Report Type: DA Access Report
Reference Number: 18148
Client: Prestige Development Group c/o Morson Group
Site Address: 16-24 Hope Street, Penrith

ACCESS REPORT

This Access Compliance Report is to accompany a Development Application for the development proposed at 16-24 Hope Street, Penrith

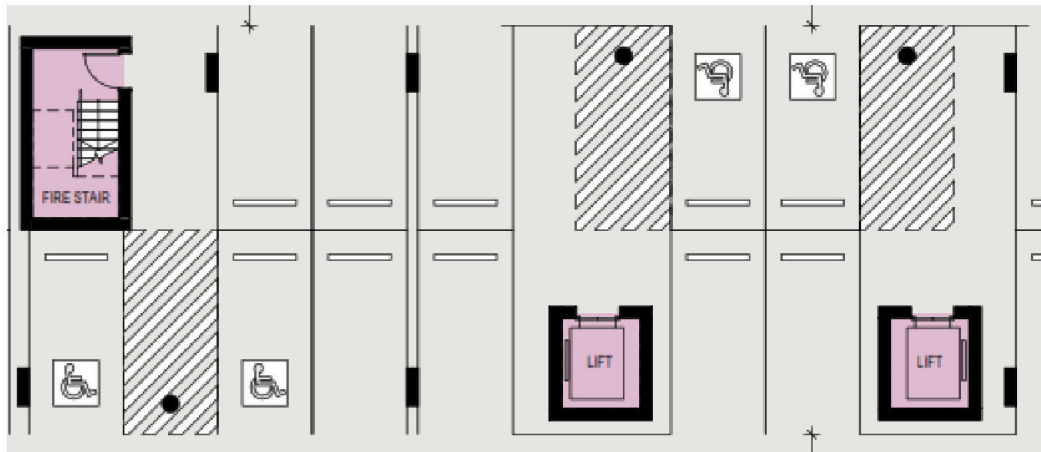
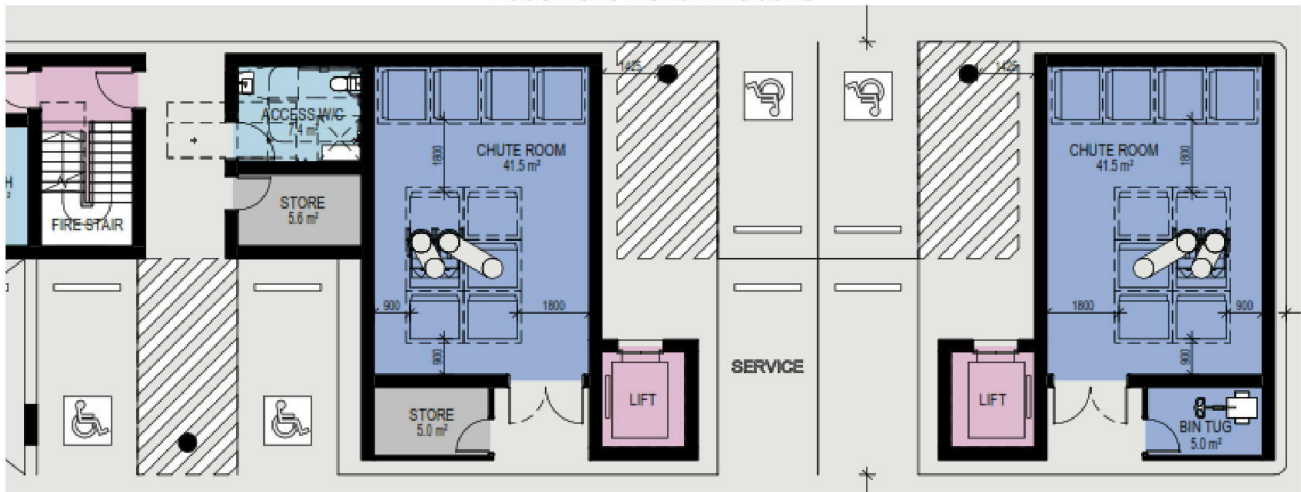
The Accessible parking, shared zones, linemarking and bollards to be as shown above.
Access symbol is not to be provided when spaces are allocated to Adaptable units.

Basement 2 shown above

Basement 1 shown above

Pre-adaptation layout

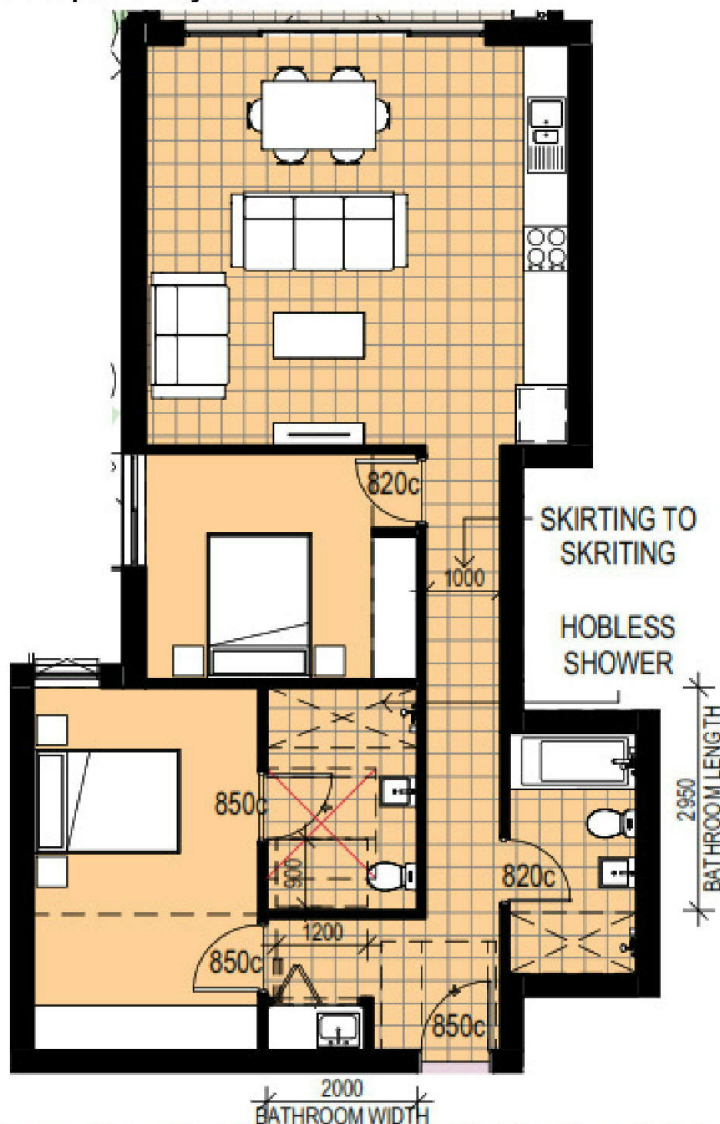
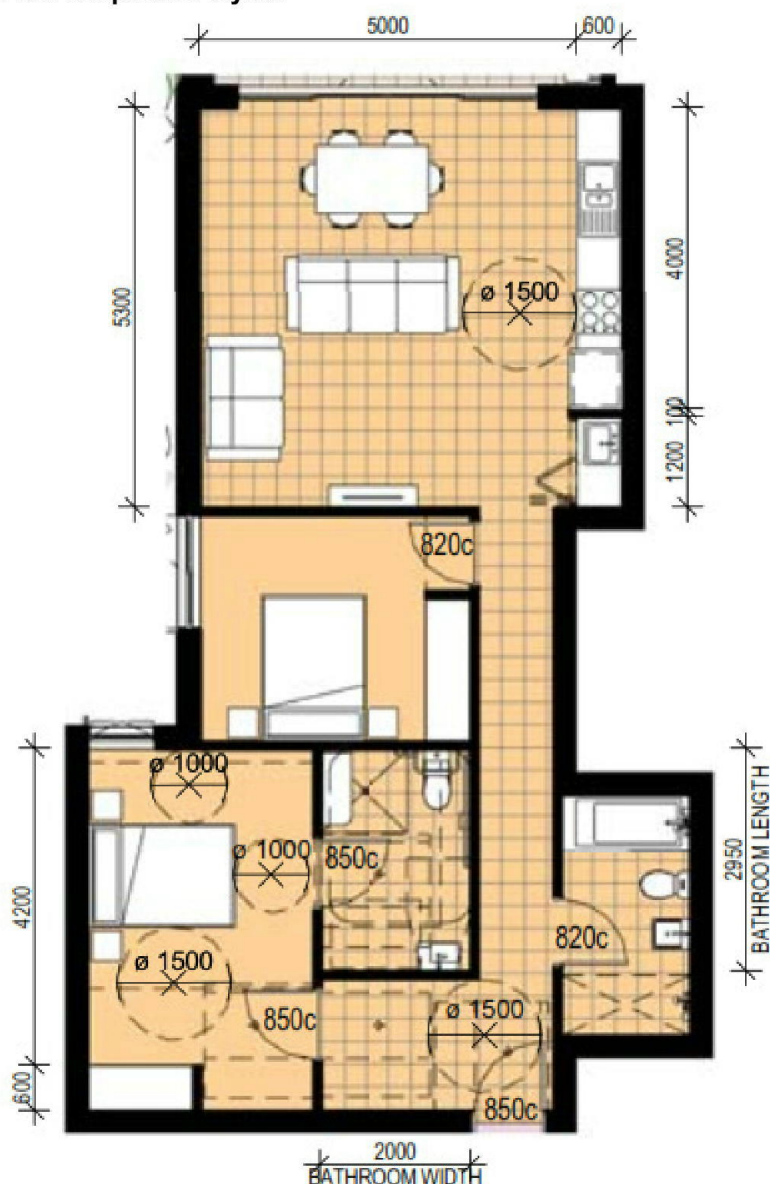
PRE ADAPTABLE AND LIVABLE UNIT

To comply with Livable, the wet areas are to be such that flush transition is available. One option to achieve this is to recess the floor slab.

Main Adaptable bathroom

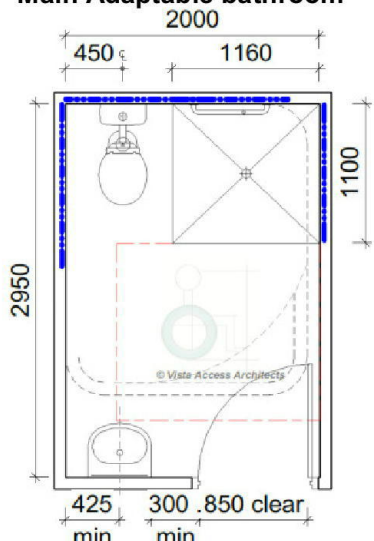
Post Adaptation bathroom layout shown

Noted dimensions in these diagrams are approximate and depend on selected features such as size of the basin. These dimensions include allowances for reinforcements and normal construction tolerances.

Thick blue line indicates the location of wall reinforcements which are to be provided at pre-adaptation itself. Red dotted line indicates the shower circulation space. Black dotted line indicates the WC pan circulation space.

Wall reinforcement requirements at Pre-adaptation

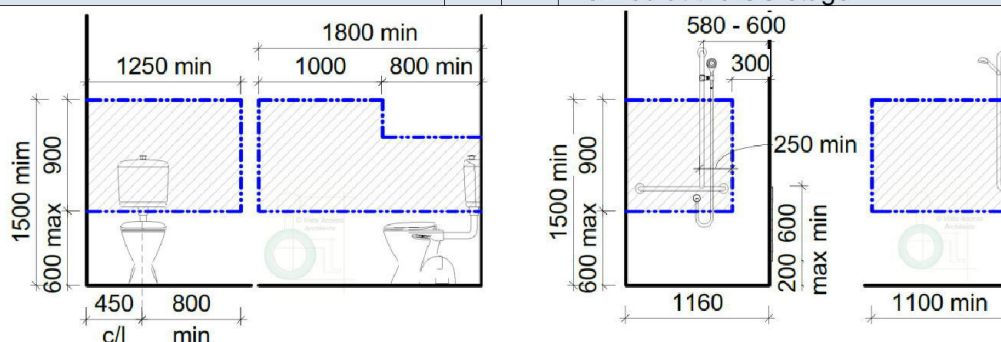
Reinforcement requirements for the Adaptable unit for WC and shower (in post-adaptive position) showed hatched. Refer to AS4299 for further details.

LIVABLE UNIT

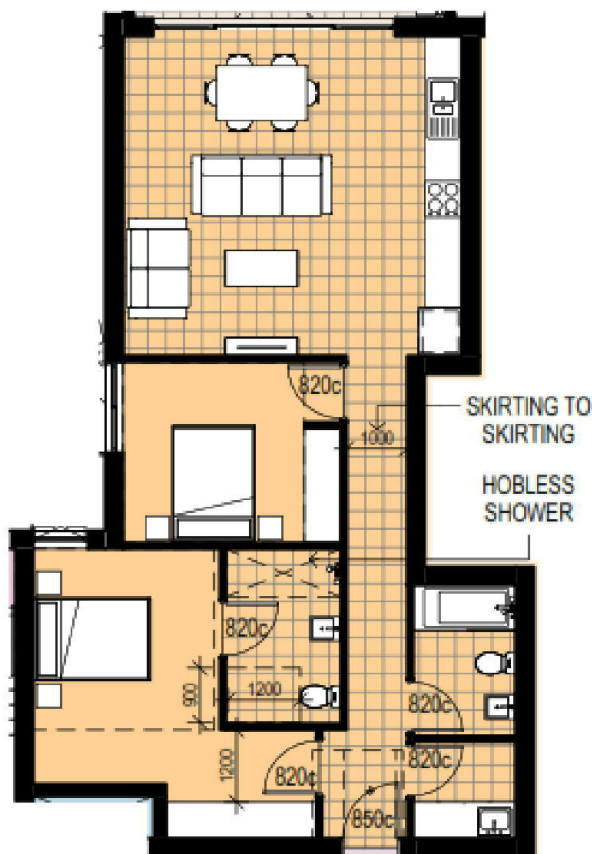
- Note that the wet areas are to be such that flush transition is available. One way of achieving this is to recess the floor slab.
